Work Order ID 140185

Item Name: Blade

ENGINEERING CHANGE NOTICE NO.		02195		SHEET 1 OF 4	
DWG NO.	646.3000	REV: N/C	PREPARED BY S. HUFF	DATE: 01/05/09	EFFECT ON DWG ☐ INC. ☒ UNINC.
DWG TITLE: LOWER CUTTER ASSY					
APPROVED BY:	ENGR <i>[Signature]</i>	MFG <i>[Signature]</i>	QC <i>[Signature]</i>	EFF:	NEXT ORDER
TRANSACTION CODES (TC): A-ADD C-CREATE R-REVISE D-DELETE		REASON: REMOVED RIVETS IN FAVOR OF ADDITIONAL SCREWS

LOWER CUTTER ASSY

SHEET 1, ZONE D5, IS:

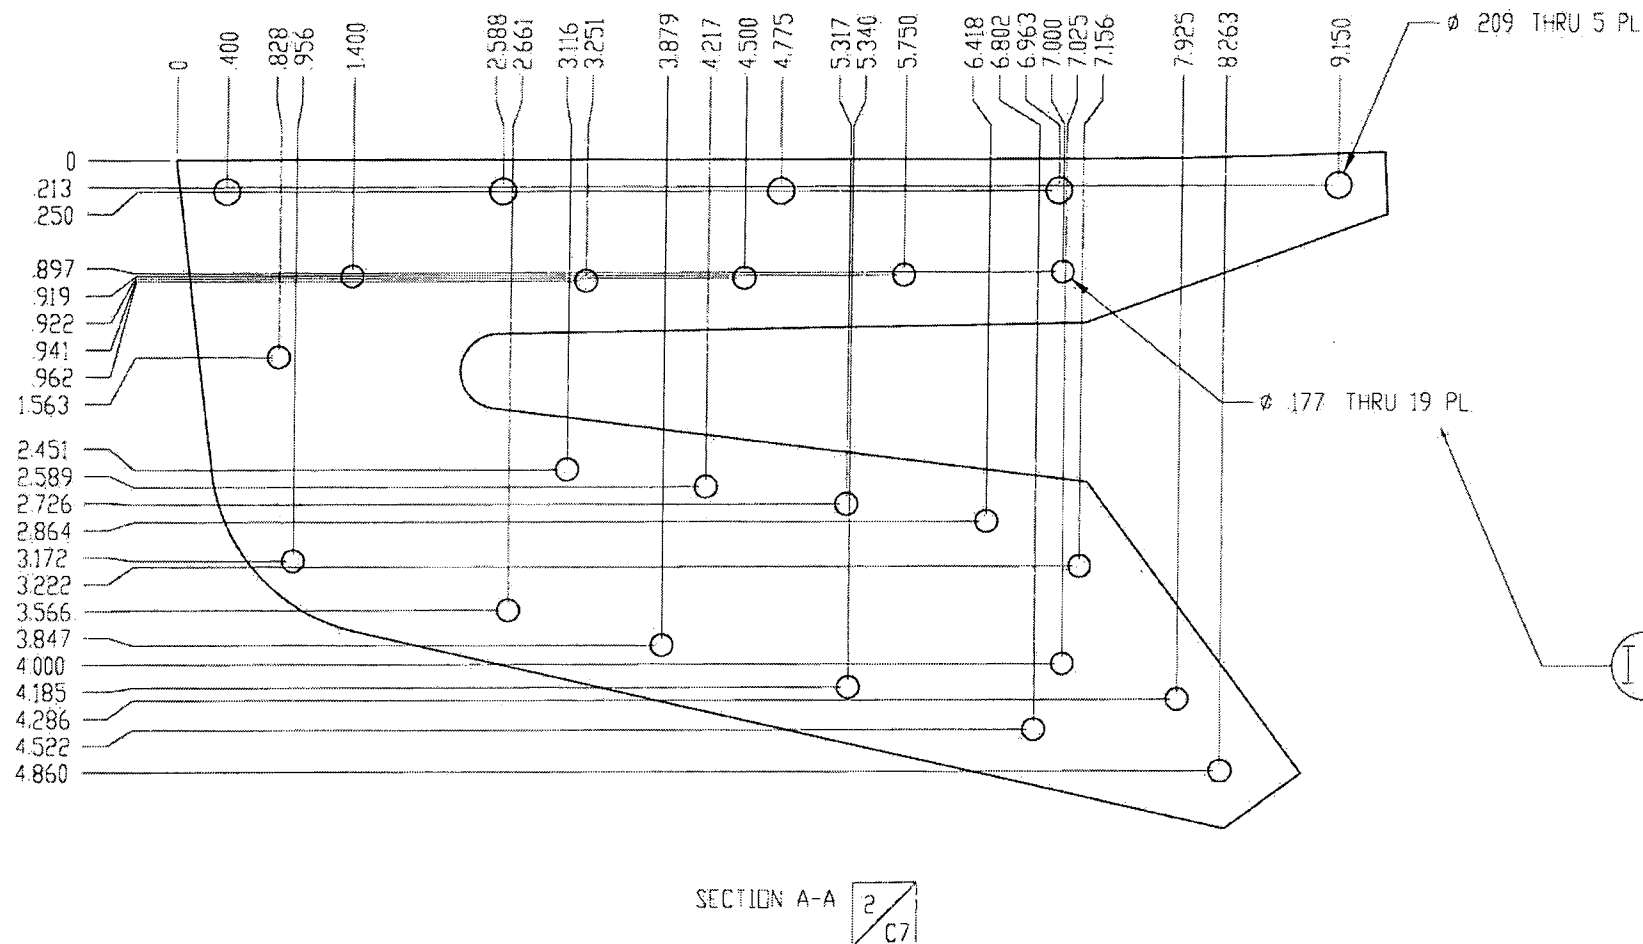
10	R	601.1541	19	LOCKNUT	MS21042L08
9	R	601.2764	38	WASHER	NAS1149FN832P
8	R	601.2765	19	SCREW	MS27039-0819
7	D	601.2766	2	RIVET	MS20470AD5-18
			3001		
F/N	TC	PART NUMBER	QTY	DESCRIPTION	MATERIAL/SPECIFICATION
DOCUMENTS EFFECTED:				☐ MDL ☒ INSTALL INSTRUC ☒ ICA ☐ FMS ☒ BOM	CHANGE CATEGORY ☐ MAJOR ☒ MINOR
				DER REVIEW REQUIRED ☐ YES ☒ NO
